Access Compliance Report

Public Rights-of-Way

Intersection ID: 28094	Main Street: MITCHELL_GLEN_DR	Cross Street: SCOTTISH_KILT_CT	Location: NW
ADA ID: 01A12E051ECB	Ramp Type: BlendTrans2	Initial Pass/Fail: Fail	Overall Compliance: No
		Severity Score: 25

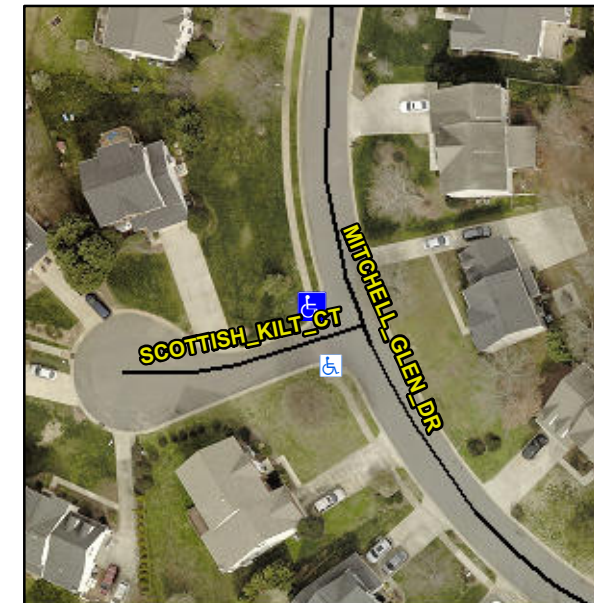
Not Found, R304.5.3

Compliance	Description	Data	Compliance	Description	Data
N/A	Ramp Length (in)	95.0	Yes	BlendTrans Slope (%)	3.3
Yes	Ramp Width (in)	48.0	No	BlendTrans XSlope (%)	12.1
N/A	Flare Type LT	N/A	N/A	Flare Type RT	N/A
N/A	Flare Slope LT (%)	N/A	N/A	Flare Slope RT (%)	N/A
N/A	Flare Traversable LT?	N/A	N/A	Flare Traversable RT?	N/A
N/A	Landing Length (in)	N/A	N/A	DWS Provided?	N/A
N/A	Landing Width (in)	N/A	N/A	DWS Contrast?	N/A
N/A	Landing Slope (%)	N/A	N/A	DWS Length (in)	N/A
N/A	Landing X Slope (%)	N/A	N/A	DWS Full Width?	N/A
N/A	Landing Curb? (Y/N)	N/A	N/A	DWS Offset (in)	N/A
N/A	Shared Landing?	N/A			
N/A	Gutter Ponding?	N/A	N/A	Gutter Slope (%)	N/A
N/A	Gutter Lip Ht (in)	N/A	N/A	Gutter X Slope (%)	N/A
N/A	Painted X Walk1?	No	N/A	Painted X Walk2?	No
	X Walk 1 Direction	To SE		X Walk 2 Direction	To NE
	X Walk 1 Width (in)	N/A		X Walk 2 Width (in)	N/A
	X Walk 1 Slope (%)	4.9		X Walk 2 Slope (%)	6.0
	X Walk 1 X Slope (%)	2.8		X Walk 2 X Slope (%)	5.7

Remove & Replace Curb Ramp With Two New Directional Ramps or Equivalent.
